# BRIDGECOR STEEL BOX STERLING RANCH ROAD- CO SPRINGS COLORADO SPRINGS, CO

**BridgeCor**  
CONTECH  
CONTRACT  
DRAWING

BRIDGECOR STEEL BOX  
38'-1" SPAN X 11'-11" RISE  
STERLING RANCH ROAD- CO SPRINGS  
COLORADO SPRINGS, CO

STERLING RANCH ROAD  
 CULVERT CROSSING  
 LONGITUDINAL PROFILE

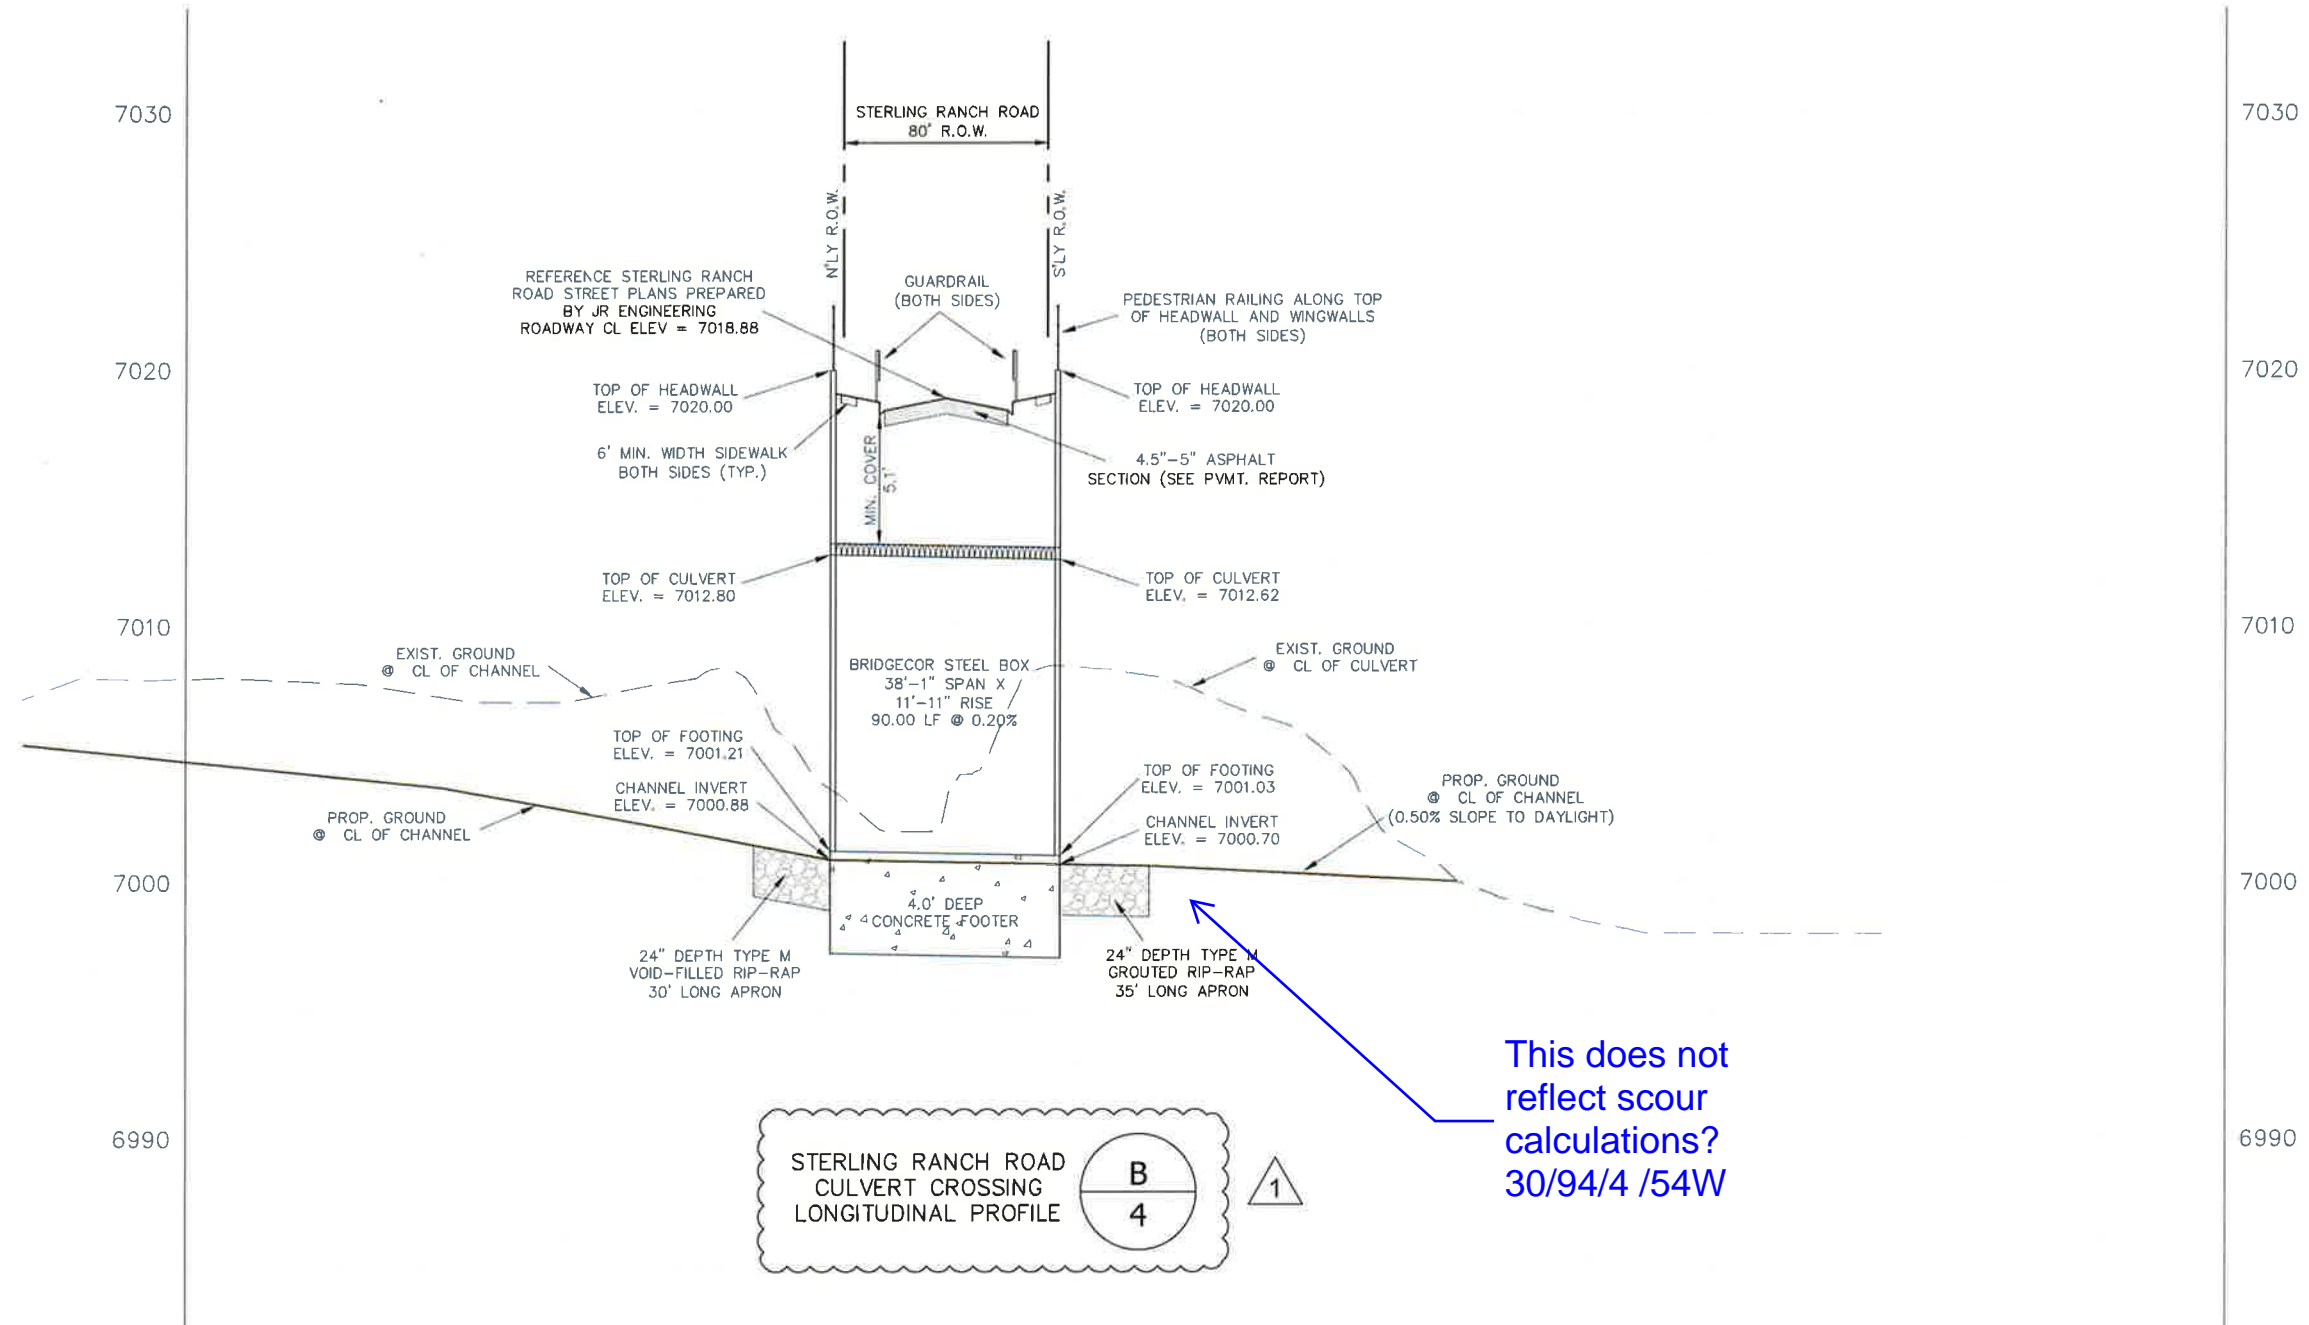
This does not  
 reflect scour  
 calculations?  
 30/94/4 /54W
